SUNDRY NOTICES AND REPORTS ON WELLS

ORYX ENERGY COMPANY

8. Well Name and No. #2

WEST INDIAN BASIN UNIT

WELL INDIAN BASIN #2	FIELD INDIAN BASIN	DATE 11-22-93
-------------------------	-----------------------	------------------

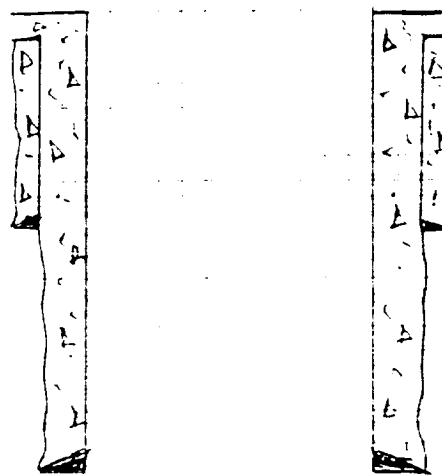
ORYX ENERGY COMPANY REQUEST PERMISSION TO MODIFY THE PROPOSED PLUG BACK PROCEDURE PRIOR TO THE DIRECTIONAL DRILLING OF THE ABOVE REFERENCED WELL.

UPON PULLING THE 4 1/2" CASING, ONLY 2671' WAS RECOVERED.

A VERBAL APPROVAL WAS GRANTED BY MR. ADAM SALAMEH OF THE BLM TO SPOT A 200' WOLFCAMP CMT PLUG FROM 5500' TO 5700' AND TAG. ALSO SPOT A CMT STUB PLUG FROM 2500' TO 2800' AND TAG.

THIS WORK IS ON-GOING. A MODIFIED WELLBORE SKETCH IS ATTACHED.

CMT Kickoff Plug (2500-2800)

Top of 4 1/2" STUB @ 2671'

Wolfcamp Plug (5500-5700)
9.5 ppg Drilling Mud
